**DESCRIPTION: Malcolm C. Hursey Montessori School at Ron McNair Campus
School Building No. 0734**

ITEM 1		No. of Pages
	1. ADD Questions and Clarifications	3
	2. ADD Specifications	6
	3. ADD Drawing Changes	6
ITEM 1.1	QUESTIONS & CLARIFICATIONS: See the attached clarifications indicating changes to be incorporated into the Contract Documents.	
ITEM 1.2	SPECIFICATIONS: In accordance with this addendum, the following specifications shall be incorporated into the Contract Documents	
	1. Section 016400 Owner Furnished Products	
ITEM 1.3	DRAWINGS: In accordance with this addendum, the following drawings shall be incorporated into the Contract Documents:	
	1. Sheet G1.02	
	2. Sheet C501	
	3. Sheet L2.01	
	4. Sheet L2.03	
	5. Sheet A1.04a	
	6. Sheet A6.14

END OF ADDENDUM No 2

BID SET
SITE DETAILS

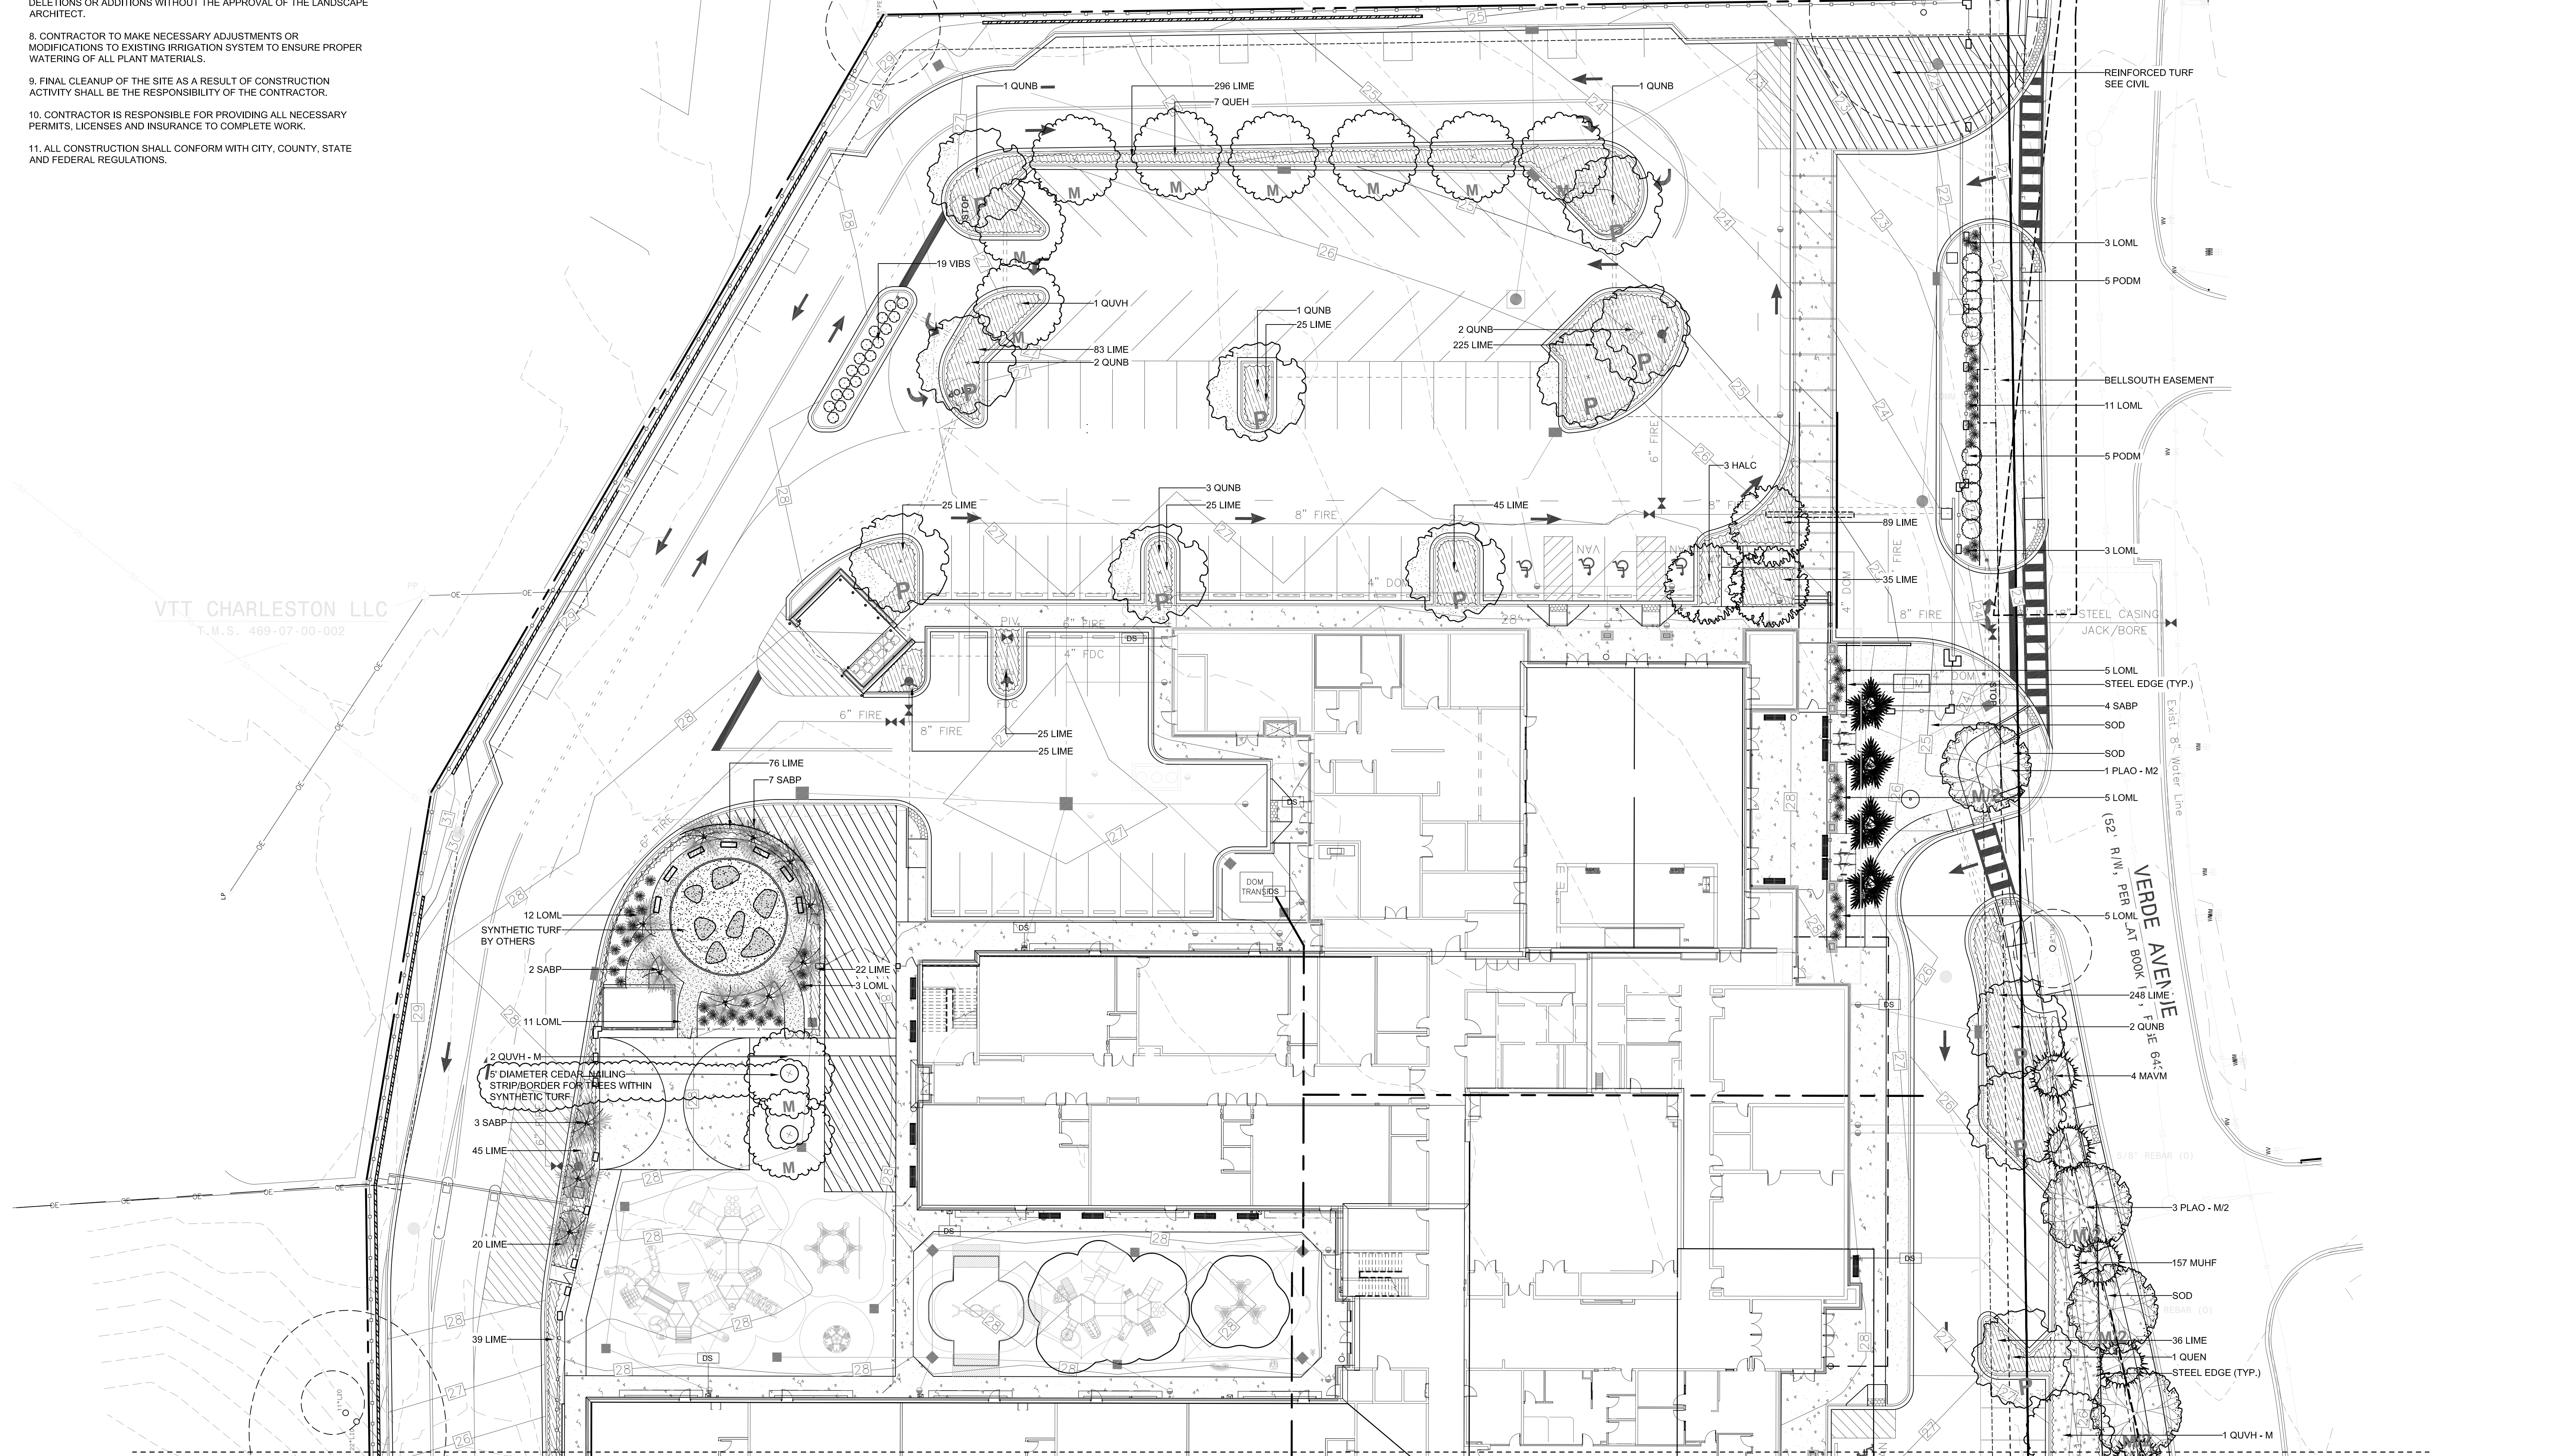
- Q2.8 Sheet L1. 01 describes 4 bike racks by cafeteria but the drawing shows 8. Which is correct?
A2.8 **Provide 4 bike racks.**
- Q2.9 L1. 01 states synthetic turf see civil. The civil drawings don't reference any turf. Please provide direction.
A2.9 **Turf and playground are by the Owner. GC is required to provide all underground drainage under the turf and any concrete cubs around the perimeter. Churchich will**

2. C5.01 SITE DETAILS
Added Synthetic Turf Details

provide and install the sub-base and turf. See L2.01, 1/L2.03 and C501 for additional information.

OVERALL ROOF PLAN

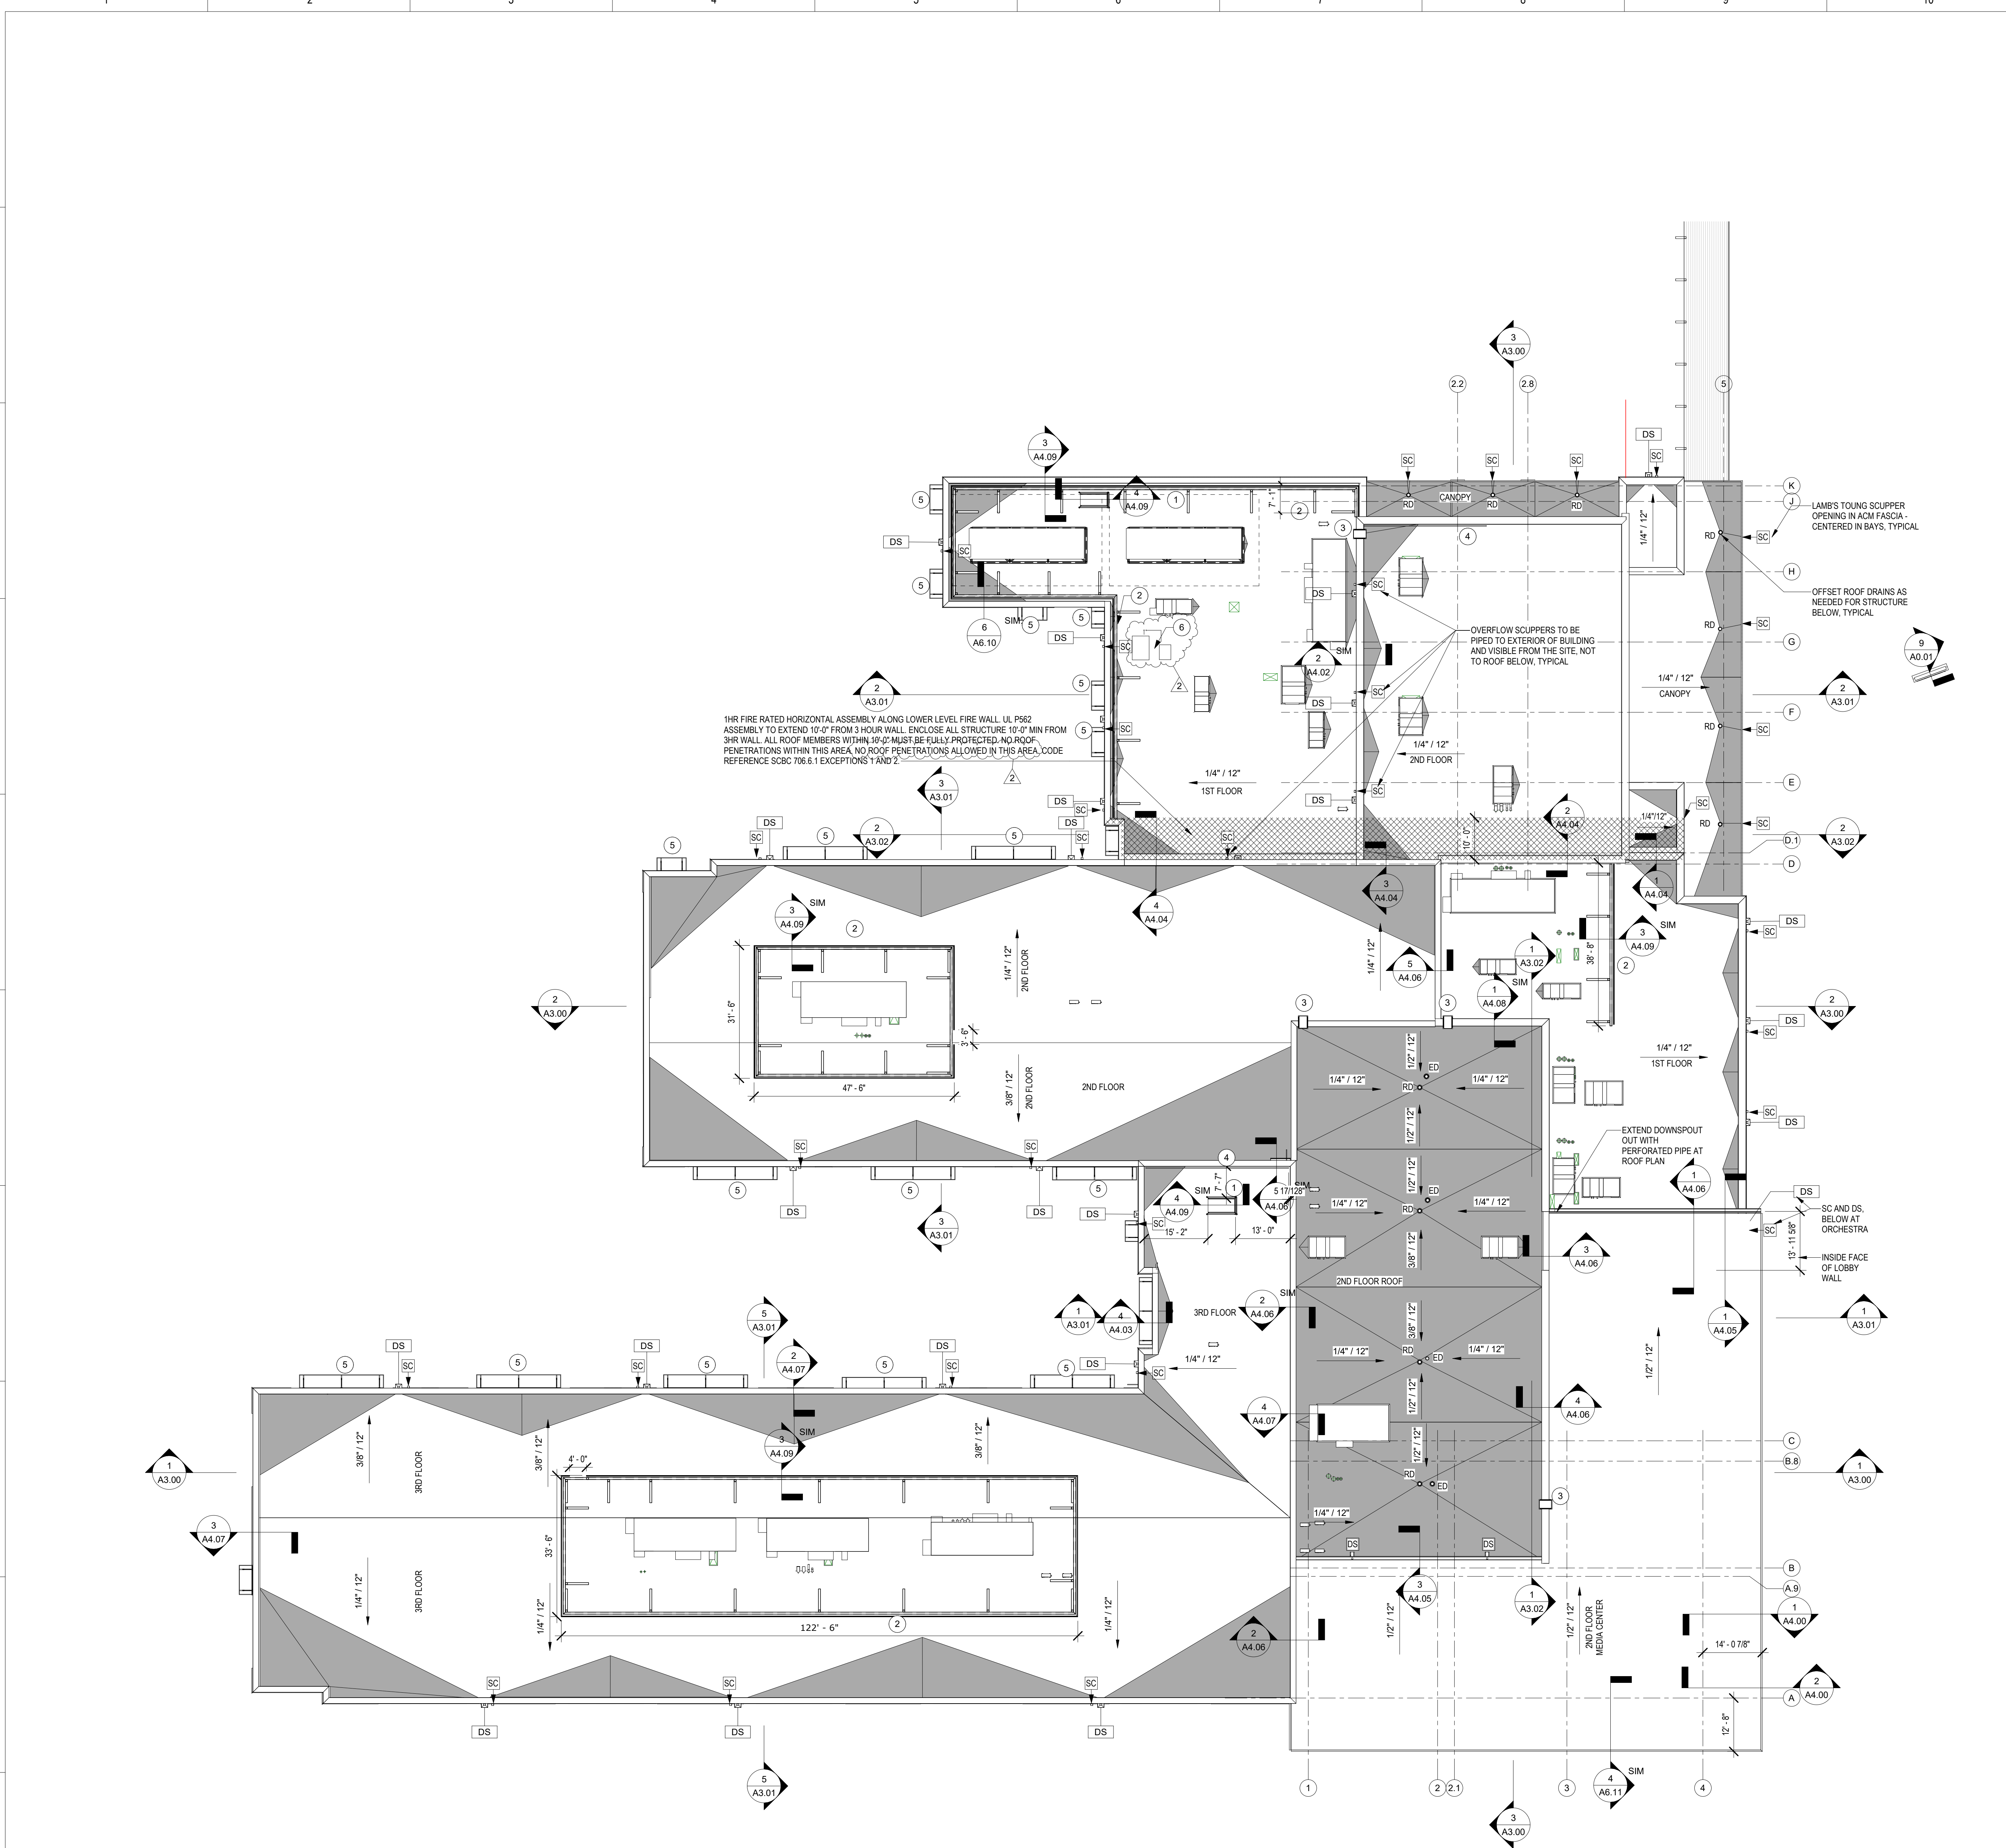
- Q2.4 Sheet G2.03 shows a 1 hour rated assembly along firewall at column line D. I understand above receiving corridor CR118, room TRD 118 and storage S156D where the roof is lower than the adjacent lower ES6 room 244, toilet 244T and project room LE240. 2/3 of the roof associated with platform 158C is above the adjacent roof. Is fire spray required there?
A2.4 **Spray fireproofing at the Platform area is acceptable. Use 1HR spray fireproofing at all structural elements that fall within 10'-0" of the 3HR wall at the platform. Members must be protected the full length and span of the supporting roof members at a minimum of 1HR has noted in the drawings. Intumescent paint to be used at all exposed areas where spray fireproofing removed for clips, anchors, etc. in accordance with the code and manufacturers guidelines. As referenced in the drawings, SCBC 706.1.1 Exception 2 states "Openings in the lower roof shall not be located within 10 feet of the fire wall."**

- Q2.7 Please confirm refrigerant piping for freezer/cooler units are to be run underground. How are they supposed to get to the top of the units inside the building?
A2.7 **Refrigerant piping does not run underground. The condensing units will be located on top of the Kitchen roof as shown on A1.04a, see attached.**

5. A1.04a OVERALL ROOF PLAN
Revisions to required fire ratings near 3-Hr wall.
6. A6.14 EXTERIOR DETAILS
Added counterflashing detail
